Scott Horsley
Water Resources Consultant
39 Chestnut Street • Boston, MA 02108 • 508-364-7818

RE: 34 Brush Hill Road, Sherborn, MA

General Comments: I have reviewed the revised plans for four, 3-bedroom homes dated December 23, 2024 and the most recent test pit data. This design represents a 25% reduction in wastewater flow and water supply demand compared to the previous design. The revised project includes a concentrated cluster wastewater disposal system, and an untreated stormwater discharge. Limited information is provided regarding the location, depth, or pumping rates of private drinking water wells on the plans. The project site is surrounded by abutters' private septic systems, drinking water wells and wetlands. The soils are comprised of glacial till which is low permeability with shallow water table. A successful site design will depend on a careful evaluation of the site's hydrogeologic conditions.

Figure 1 – Groundwater Mounding Results

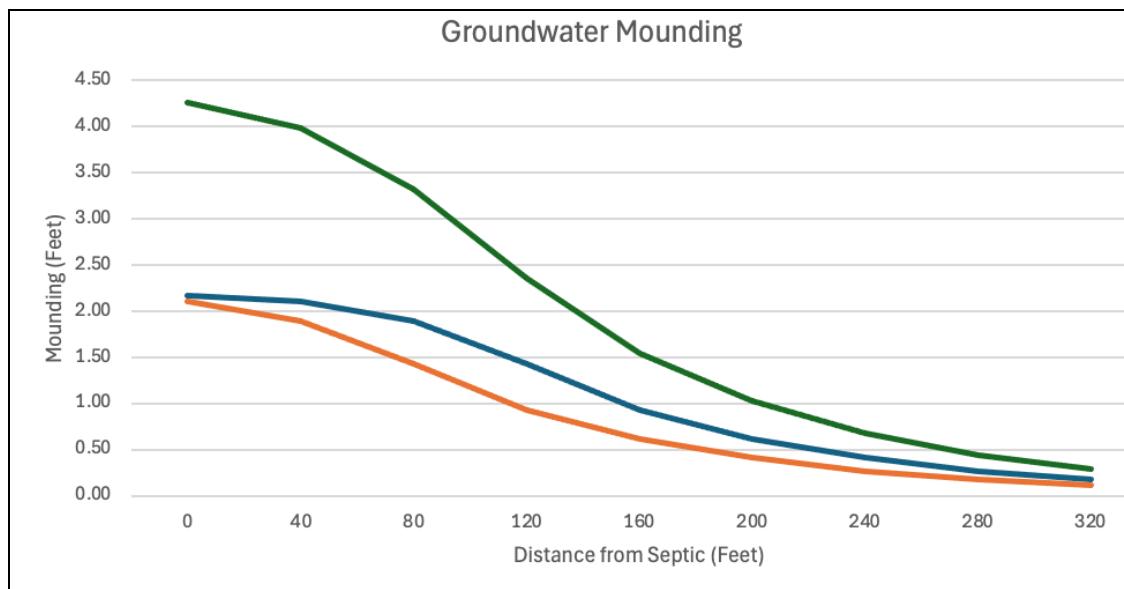
1. The proposed septic system will cause groundwater mounding which will likely compromise Title 5 compliance issues.

The Applicant has previously indicated they do not intend to provide the hydrologic analyses required by the Sherborn Health Regulations and Environmental Health Impact Report (EHIR). Therefore, I have conducted a revised preliminary groundwater mounding analysis for the new 12-bedroom septic system, using the Hantush model¹. As with the prior mounding analysis I provided to these Boards on September 30, 2024, I have utilized publicly-available hydraulic conductivity and specific yield values published for this area by the Massachusetts Hydrogeologic Atlas and the dimensions of the soil absorption system and saturated thickness provided by the Applicant (see Appendices to letter). I have utilized mirror imaging to evaluate the cumulative effects of the retaining wall/impermeable barrier shown on the plans.² The resulting analysis indicates that the groundwater mounding beneath the system will rise 4.3 feet and will inundate the wastewater soil absorption system (see Table 1 and Figure 1). This effectively reduces the vertical separation between the leaching field and the mounded water table to zero (0) and does not comply with the Title 5 requirement for a 4-foot separation.

The groundwater mounding analysis also indicates significant water table rises on the abutting parcels. A water table rise of 2.4 feet is predicted at the property boundary at 32 Brush Hill Road and 0.29 feet (3.4 inches) at the septic system on that property. According to our records that septic system was designed with a 4.0-foot vertical separation to ESHGW. The predicted groundwater mounding would reduce this to 3.7 feet and would cause the system to go out of compliance with Title 5.

- a) Conduct a groundwater mounding analysis to determine the effects the proposed discharge of 1320 gallons/day of wastewater and the effects of the proposed retaining wall/impermeable liner that surrounds the wastewater infiltration area.
- b) Identify plans for water supply well(s) and evaluate impacts on neighboring wells to determine if there would be interference between wells and a reduced capacity available to the neighbors.
- c) Prepare Environmental Health Impact Report in accordance with Sherborn Health Regulations.
